CONDITIONS OF APPROVAL:

Open Issues: 8 These issues are currently being filtered

7. Flood Overlay

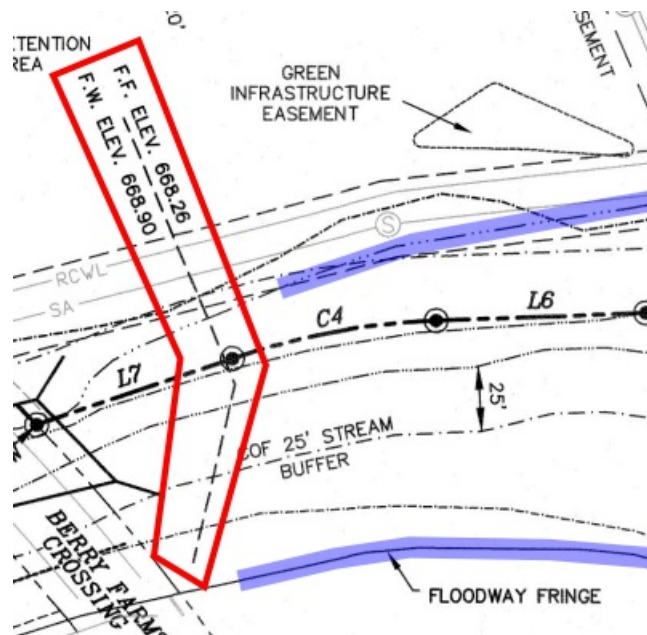
joe.marlo@franklintn.gov Floodway Overlays changed (thank you).

Applicant to match Floodway Fringe line type on each side of stream (see lines highlighted in blue below). Applicant to verify F.F. and F.W. elevations shown with current overlays, and delete if not applicable (boxed below in red).

18. Domestic water

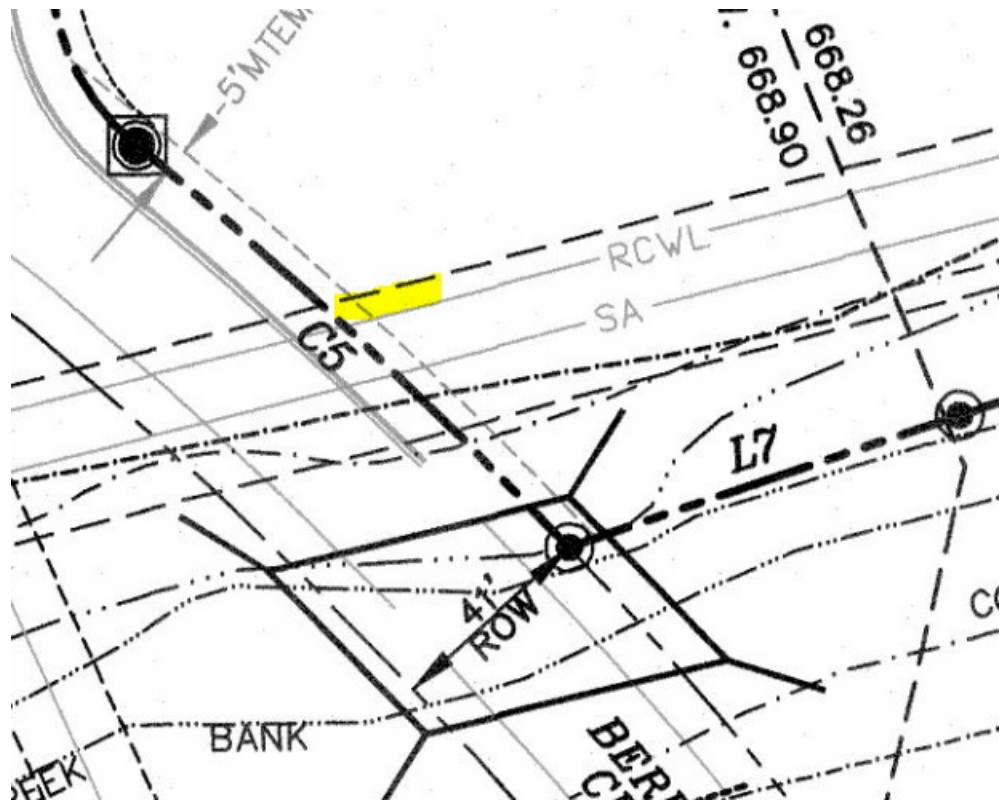
ben.mcneil@franklintn.gov Applicant did not fully address issue, the waterline was added to match the approved site plan, but the 20' PUDE is not acceptable. All Franklin water, sanitary sewer and reclaim easements are to be labeled as exclusive. Applicant shall revise.

22. Domestic water

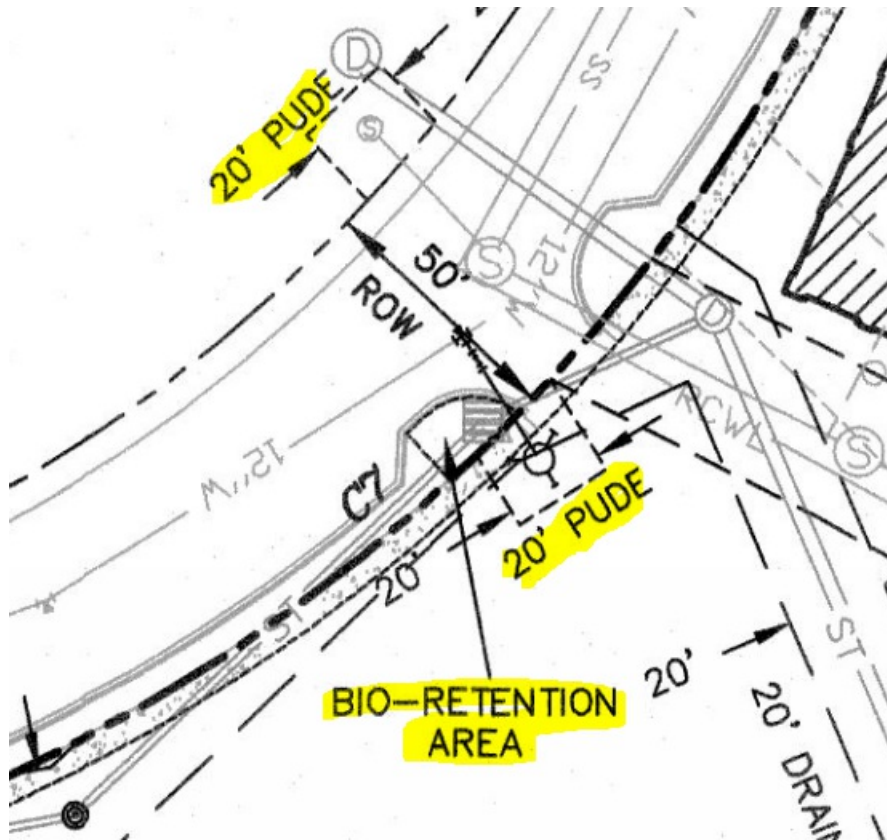
ben.mcneil@franklin.tn.gov Applicant failed to address issue, applicant shall ensure the storm and domestic water match the revisions made on site. My records indicate that the bio-retention was revised to allow for separation of the water. The field inspector has confirmed that a revision was completed in the field to ensure the bio-retention and easements are separate.
